ORDINANCE NO. 2025-20**ORDINANCE TO CREATE THE PLANNED UNIT DEVELOPMENT OVERLAY
DISTRICT FOR THE DEVELOPMENT REFERRED TO AS BUBBLE'S FOAM FARM**

WHEREAS, the Village has received a petition from Bubble's Foam Farm, hereinafter referred to as the Petitioner, for creation of a PUD hereinafter referred to as the Bubble's Foam Farm PUD, which PUD will, amongst other conditions and restrictions, permit carwash type use on Lot #1 of CSM #5382; and

BUBBLES FOAM FARM PEWAUKEE

PRELIMINARY LANDSCAPE PLAN

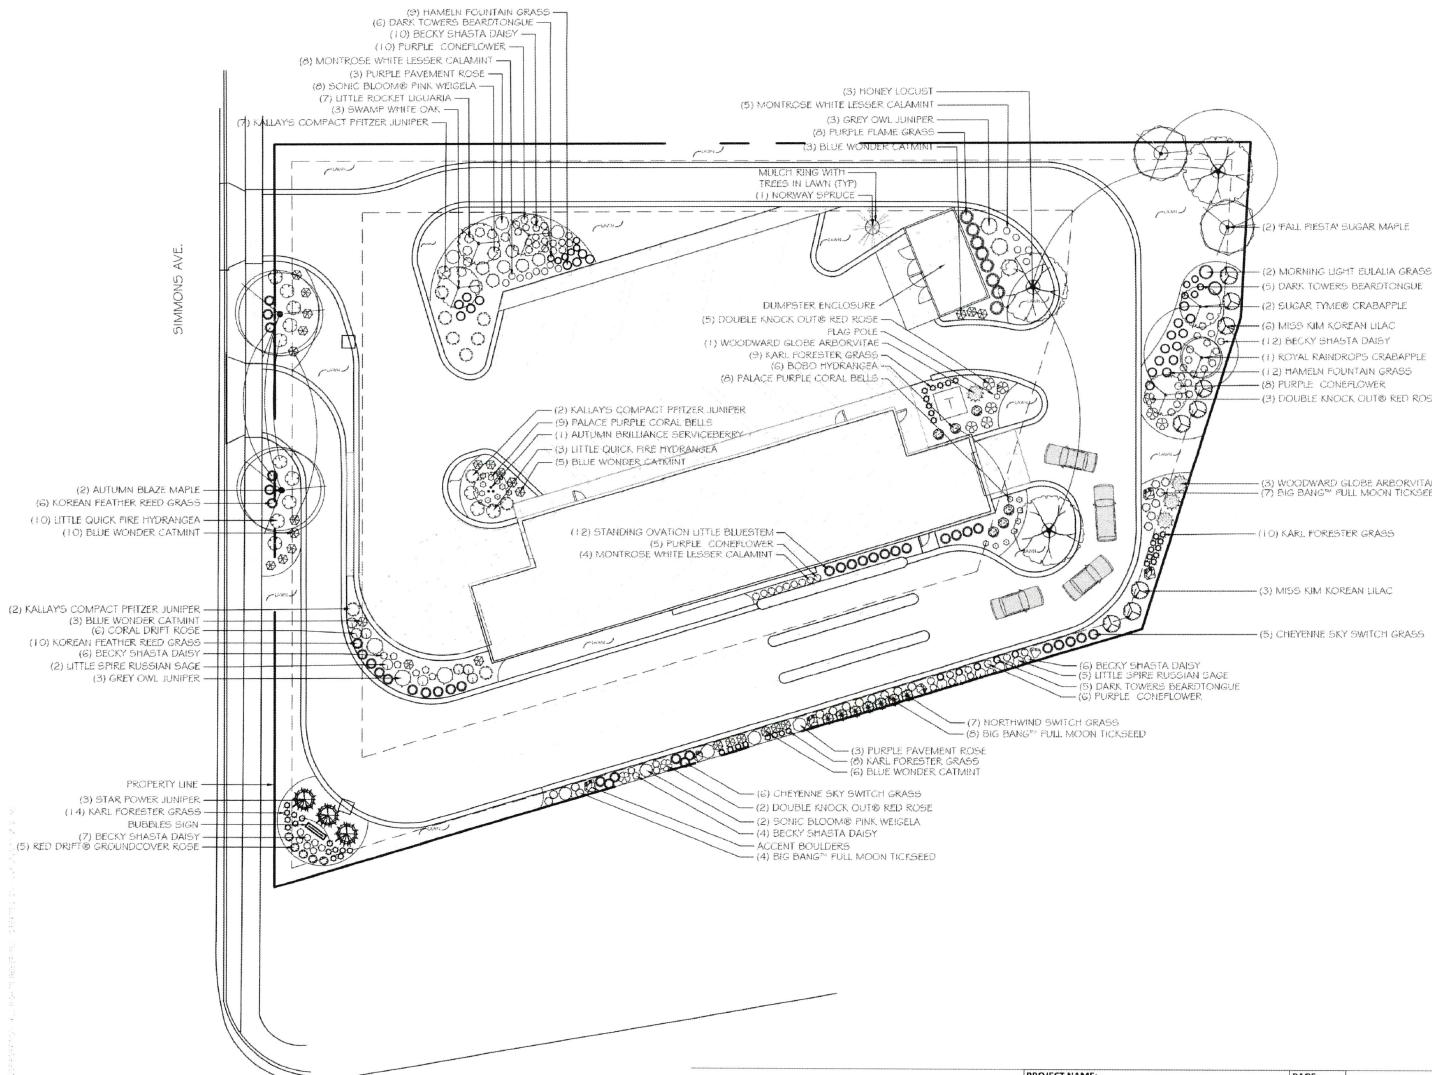
- 27) Landscape plan: Some proposed shrubs are shown in public right of way. Move the proposed shrubs on to the private property.
- 28) In public right of way, any sidewalk panels with cracks, spalling or missing pieces or misaligned panels must be removed and replaced by Applicant. Village Engineering staff or designated representative to mark panels for removal. Show on drawing for review and approval. Based on initial review, there are 8 panels along Simmons Dr and 1 panel along Capitol Drive. There are 13 panels along the back of curb along Simmons that need to be removed and restored with turf. A right of way permit is needed to remove or replace sidewalk and to follow Village sidewalk specification.
